International Aero Engines SERVICE BULLETIN

**ENGINE - LP COMPRESSOR - INCORPORATION OF STRONGER
BOLTS FOR THE LPC BLEED DUCT TO FAN FRAME**

Jun. 29/99

V2500-ENG-72-0333

Location of the bolts that connect
the LP bleed duct to the fan frame
Figure 1

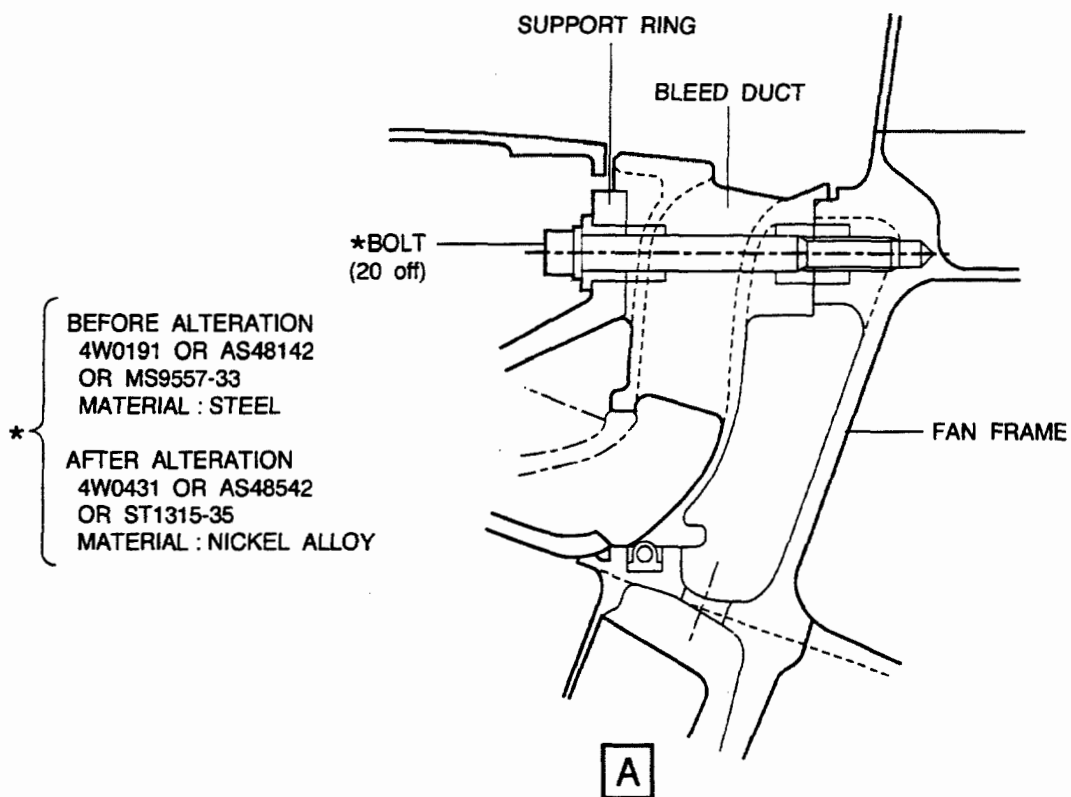
The extension of bolts which join the LPC bleed duct and the fan frame was experienced on a V2500-A1 engine that had a Fan blade-off.

Analysis shows that the fan blade-off load causes the extension of the bolt.

The material of bolts that connect the LP bleed duct to the fan frame has been changed from steel to nickel alloy.

Install new 4W0431 (20 off) bolts, in place of 4W0191 (20 off) bolts.
Install parts per V2500 Engine Manual. (Ref. Chapter/Section, 72-32-00,
Assembly-08, Config-1 or Config-2)
